Thanks for the opportunity to comment on the proposals for Town Park, Berewood.

The method statement reference Ref: May 2024 JFA9524 is generally fine and is to be conditioned in full subject to three points please:

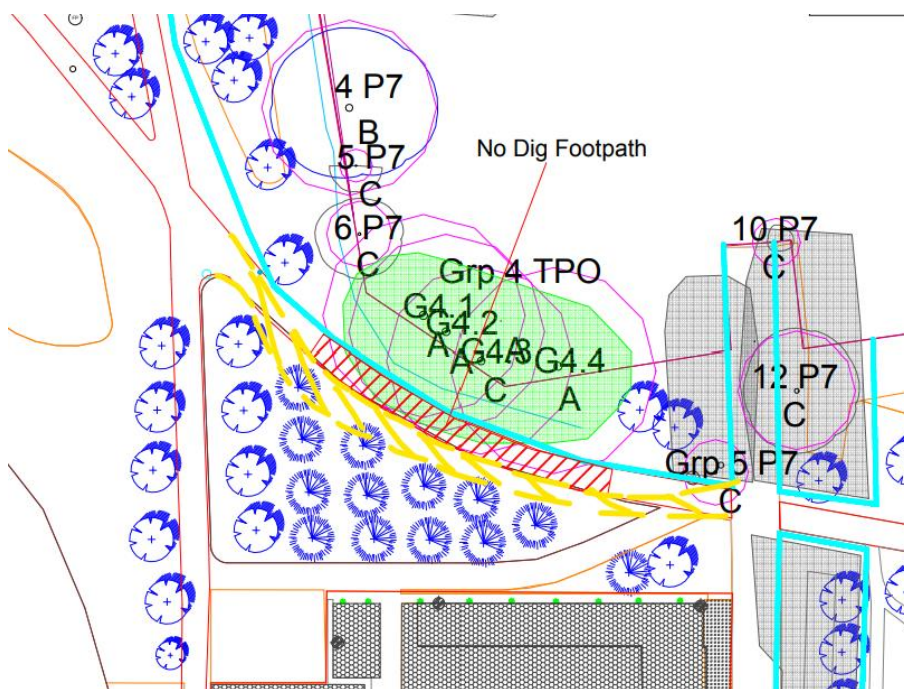
1. Category A trees are ideally retained without disturbance. There is a footpath proposed over the RPA of G4 – a group of 4 TPO'd yew trees of significant girth. Even though this is proposed with a no-dig solution, it would be far preferable to have it installed further south, away from the RPA of the trees:

The path can easily be moved south to completely avoid the root plates of these important trees: new line indicated in yellow below:

I would urge this is done as it removed the potential for damage to the most important part of the RPA. It will mean the relocation of one or two new plantings but there is plenty of scope for this away from existing trees.
